**MONTGOMERY COUNTY HISTORIC PRESERVATION COMMISSION**  
**STAFF REPORT**

<b>Address:</b>	5904 Cedar Parkway, Chevy Chase	<b>Meeting Date:</b>	9/19/2018
<b>Resource:</b>	Outstanding Resource Chevy Chase Village Historic District	<b>Report Date:</b>	9/12/2018
<b>Applicant:</b>	David O’Neil & Laura Billings (David Jones, Architect)	<b>Public Notice:</b>	9/5/2018
<b>Review:</b>	HAWP	<b>Tax Credit:</b>	Partial
<b>Case Number:</b>	35/13-18Z	<b>Staff:</b>	Dan Bruechert
<b>Proposal:</b>	Garage demolition, non-historic addition removal, new construction, hardscape, and landscape alterations.

Staff recommends that the HPC **approve with three conditions** the HAWP application.

Figure 1: Stone tower with arbor/pergola.

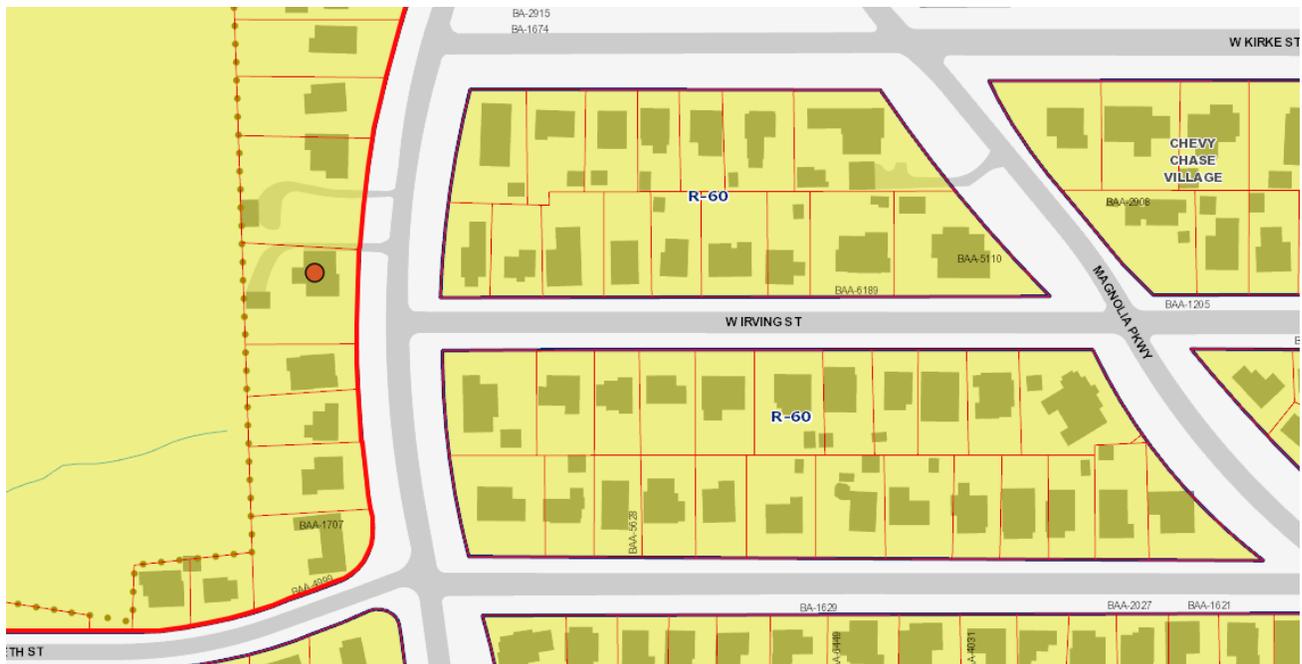
In the south end of the property there is a folly/gazebo that is connected to the house by a pergola. These elements are constructed from masonry that matches the construction of the house foundation. The pergola is largely overgrown with vines and ivy, with the remnants of deteriorated wood fencing between the columns (see the image below). The applicant proposes to add a second row of columns to the pergola, behind the existing historic columns and construct a new pergola structure. Aligned with these new columns the applicant proposes to install a 5' (five foot) iron fence enclosure with a gate (discussed below). Based on the input from the HPC at the two preliminary consultations, Staff finds the proposal to add a new row of stone columns is appropriate. The applicant proposes to match the column design and materials. Staff finds that alterations to this feature is most analogous to gazebos, which should be subject to moderate scrutiny. Staff further finds that expanding this feature in a matting design is an appropriate treatment within the Chevy Chase Village Historic District, per the *Guidelines*.

3. A sample board of the stone and mortar for the new pergola columns needs to be created for review and approval with final approval authority delegated to Staff; and with the general condition applicable to all Historic Area Work Permits that **the applicant will present 3 permit sets of drawings to HPC staff for review and stamping prior to submission for permits (if applicable)**. After issuance of the Montgomery County Department of Permitting Services (DPS) permit, the applicant will arrange for a field inspection by calling the DPS Field Services Office at 240-777-6370 prior to commencement of work and not more than two weeks following completion of work.
